**RE: Zoning and Engineering Review of Prestwick Place Preliminary PUD Development Plan
Response to The Kleingers Group Technical Review Letter dated August 26th, 2016**

Prestwick Place Pierce Township, Clermont County, Ohio

Typical Perimeter Landcape Buffer and Proposed Entry Monument

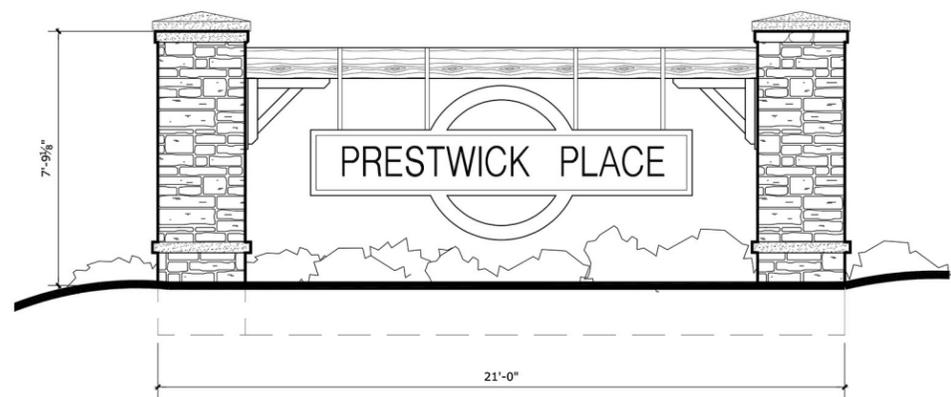
COMMENT #1: *Conceptual Landscape Plan. I would recommend that a conceptual landscape plan be submitted at this stage addressing any project gateways, streetscaping, typical bufferyard design, screening or other required landscape or buffer elements. The applicant provides text notes for some of these items, but an overall conceptual landscape plan allows the Township to review the proposed landscape and buffering treatments in the context of the overall development and to ensure an attractive and well planned community. A conceptual (graphical) plan is required for the Township to properly review and understand if the spirit and intent of Article 10 "Landscaping and Buffering" is being achieved.*

COMMENT #4: *Gateway Entry Signage. The site plan notes that entry identification will be installed at the entrances. I would recommend that the proposed entry sign elevation drawings be submitted as a part of this preliminary stage. The sign drawings should provide the Township with the design, materials and proposed colors for the entry signs. I would also recommend that the locations of the sign footprints be shown on the plans.*

RESPONSE: A conceptual landscape plan for buffer yards along Merwin Ten Mile and White Oak Roads are attached for review.

RESPONSE: A conceptual entry monument is attached for review.

PRESTWICK PLACE
OUTDOOR LIVING PAVILLION
9.2.2016

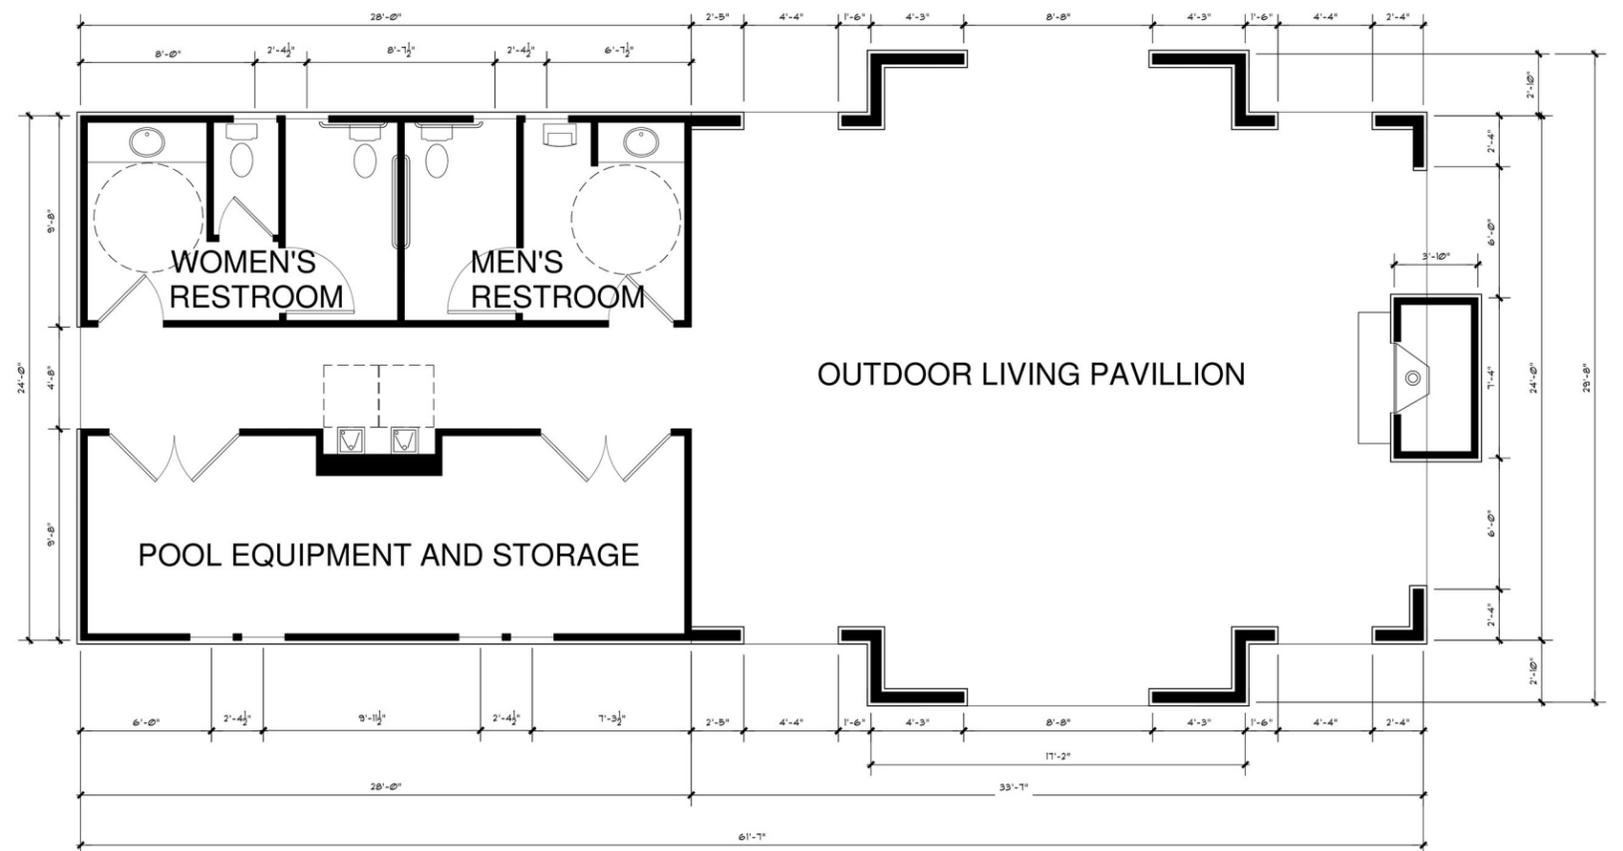
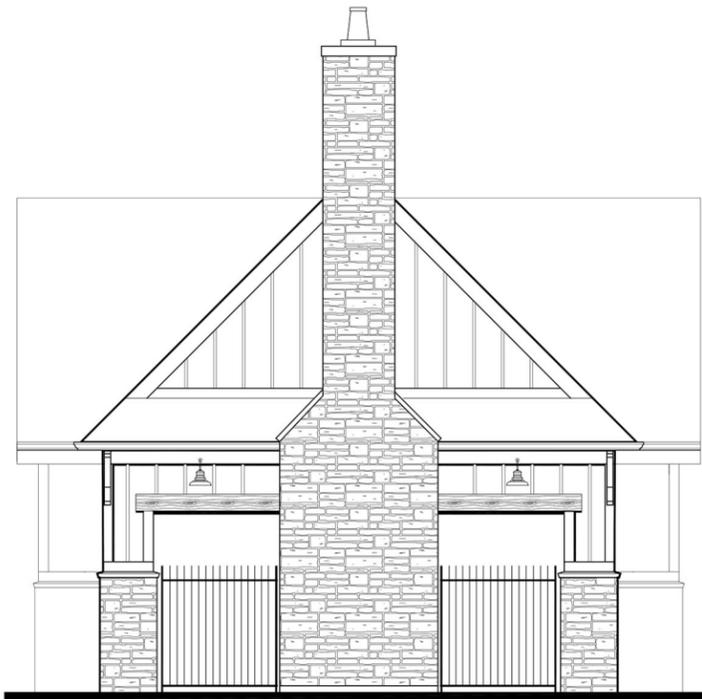
COMMENT #3: *Recreation Center and Park Area. I would typically require additional design details on the various elements of the recreation center, park area and any other active amenity areas at this stage of PUD review. This would include a conceptual site plan for the recreation center / park area providing sufficient level of detail and notes to allow the Township to properly review the extent and design of the proposed amenity package. I would also recommend that preliminary/ conceptual building elevations for the recreation center be provided at this preliminary development plan stage.*

RESPONSE: A conceptual plan for Amenity Center is attached for review.

Street Light, Street Sign, and Horse Type Fencing Examples

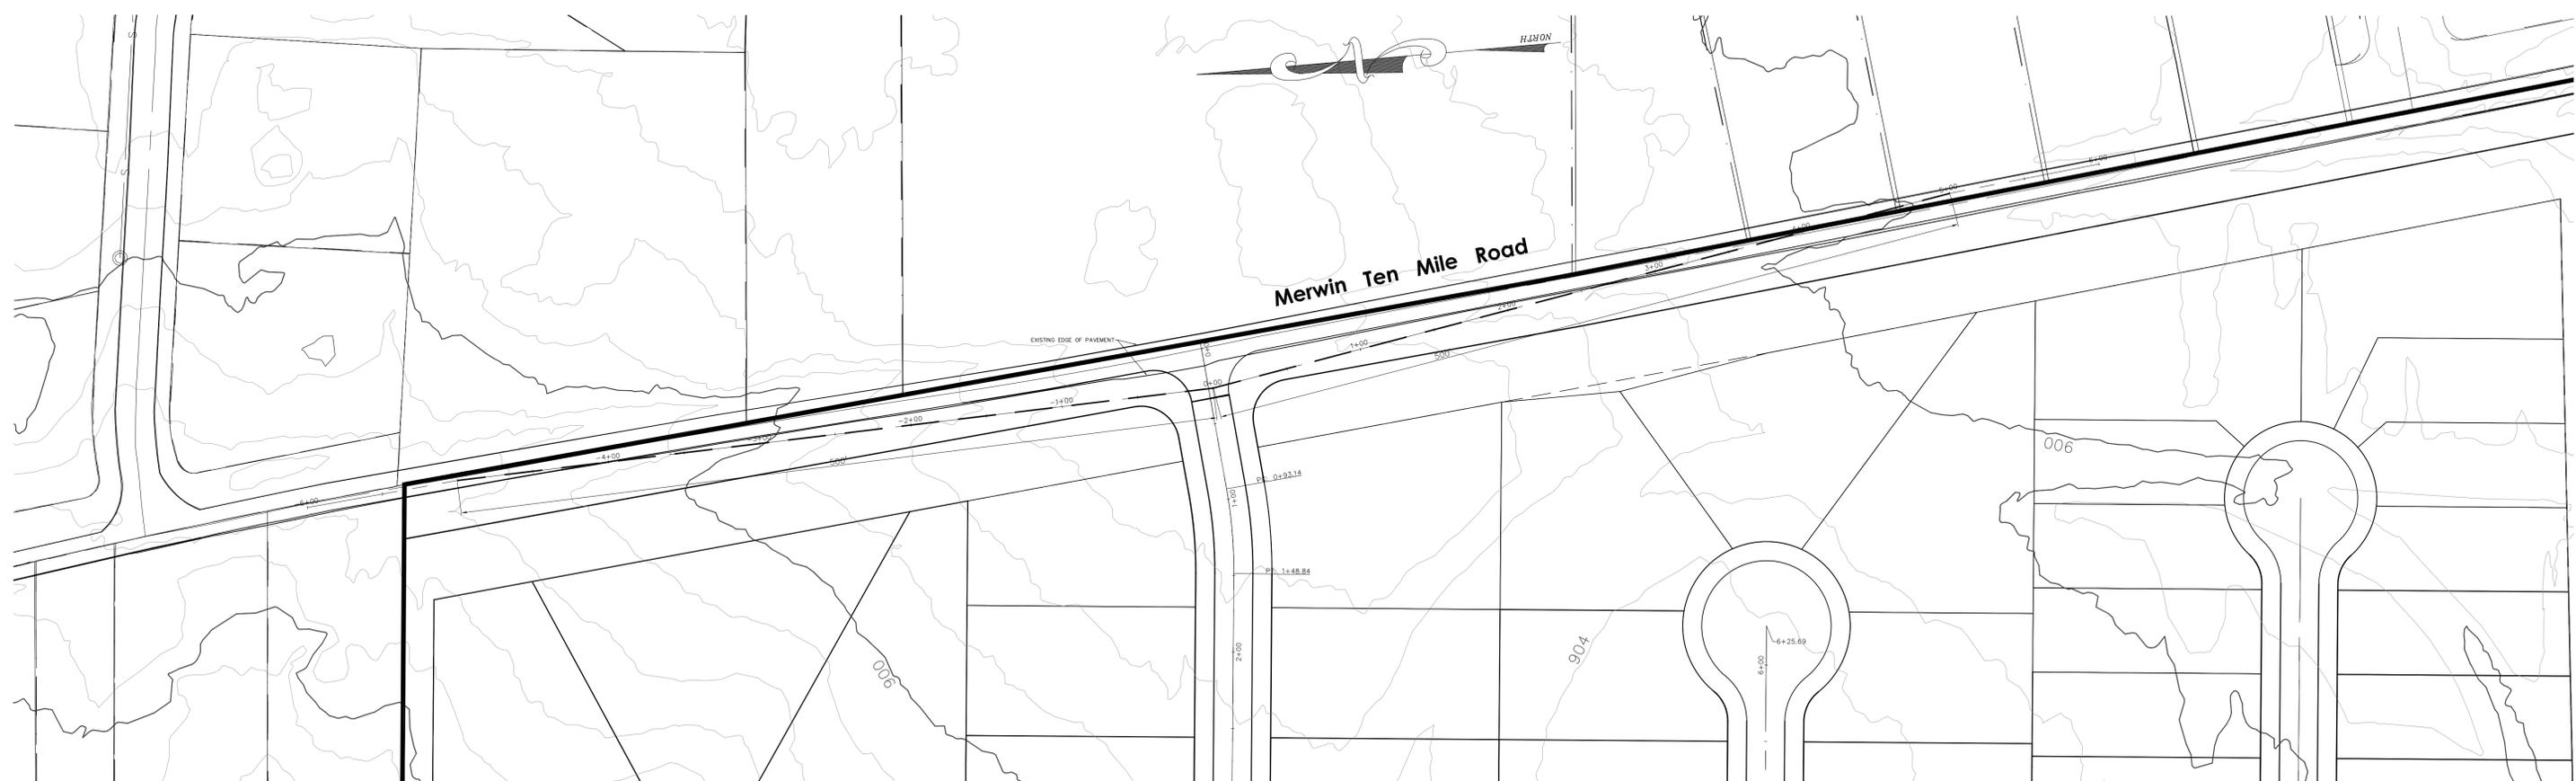
COMMENT #5: *Fencing Details. The fencing proposed around the open space is listed as "horse-park type" fencing as a note on the site plan sheet. I would recommend that a typical fence section be submitted for review by the Township.*

COMMENT #6: *Street Signs, Lighting, Other Street and Site Furnishings. I would recommend we see sample imagery or specifications for the proposed street lights, street sign poles and other furnishings such as benches, trash receptacles, etc.*

RESPONSE: A sample photograph for the fencing is attached for review.

RESPONSE: Sample photographs for the street lights and street sign is attached for review. Details such as benches, trash receptacles, etc. as typically determined as part of final construction drawings.

MERWIN SIGHT LINE
 1"=50' HOR. / 1"=10' VERT.

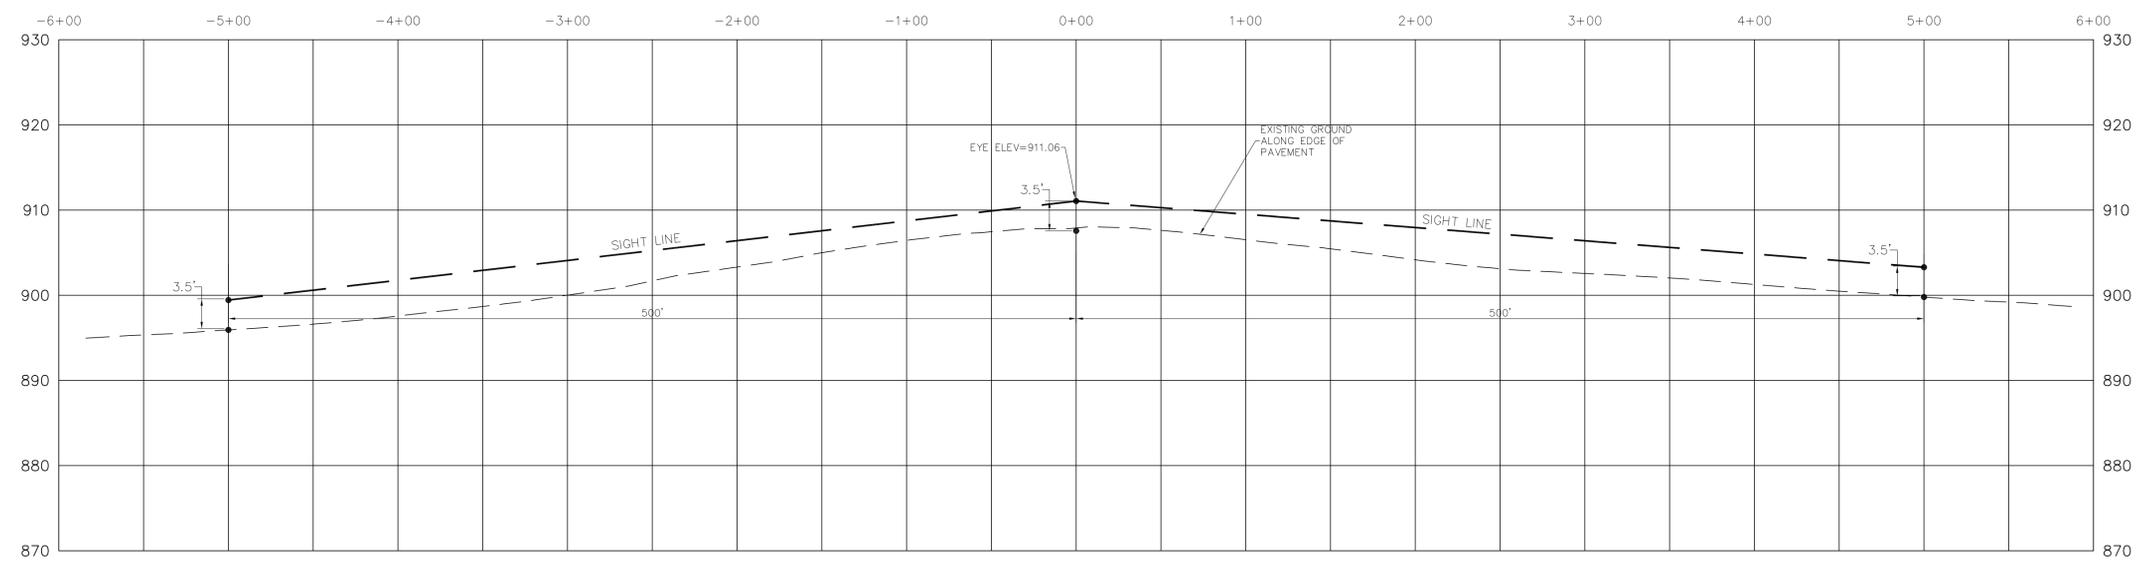
COMMENT #3: *The traffic study should document the sight distance from each of the proposed access roads on Merwin Ten Mile Road and White Oak Road.*

RESPONSE: Sight distance studies are attached for review, but are required as part of the Subdivision Plan review, not Traffic Impact Studies. Therefore, these studies will not be included in the TIS document.
